Re: Product Change Notice

## Product Change Notice for CONSMA003.031 and CONREVSMA003.031

PCN #: LPCN-130617-3

Manufacturing change for CONSMA003.031 and CONREVSMA003.031

Figure 2: CONSMA003.031 and CONREVSMA003.031 with insulation retention dimples

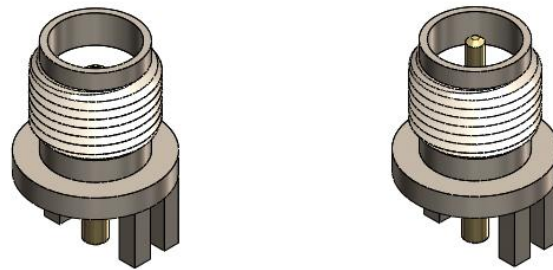
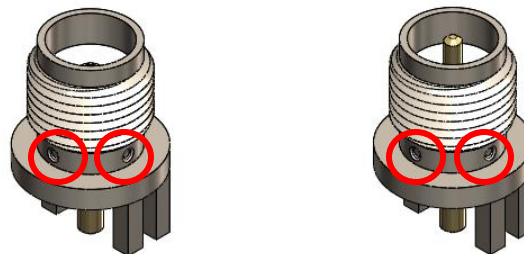
The product is mechanically identical to, and offers equivalent electrical performance, as the previous version of the product. The manufacturing change made is the addition of four retention dimples equally spaced around each connector's barrel to enhance insulation retention after connectors are subjected to solder reflow temperatures.

The addition of retention dimpling to the manufacturing process for the CONSMA003.031 and CONREVSMA003.031 has been implemented. The dimpling of the connectors is illustrated in Figure 2 below.

To enhance retention of connector insulation after being subjected to solder reflow temperatures 260° Celsius.

Form: Addition of retention dimples 90° apart on barrel of connectors
